Bulletin No. SB-00-03-13
Release Date: 1/9/13
Effective Date: 1/9/13
Supersedes: NA
Completion Date: 3-1-14
(Prior to 2014 Operating Season)
Pages:

SERVICE BULLETIN

Service Bulletin Name: SB-00-03-13 Drivers Station Side Curtains

Applicable to: All RTD Duck Drivers Station Side Curtains

CONCEPT DETAILS

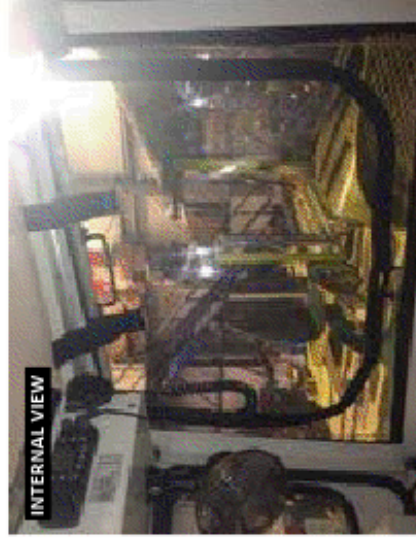
Curtain material frame mounts to the outside of the Ducks steel window frame with the use of Velcro.

Add half turn fasteners at the corners of the curtains material frame to ensure a positive connection is maintained.

Use a zipper to open and close the curtains Vs. Velcro.
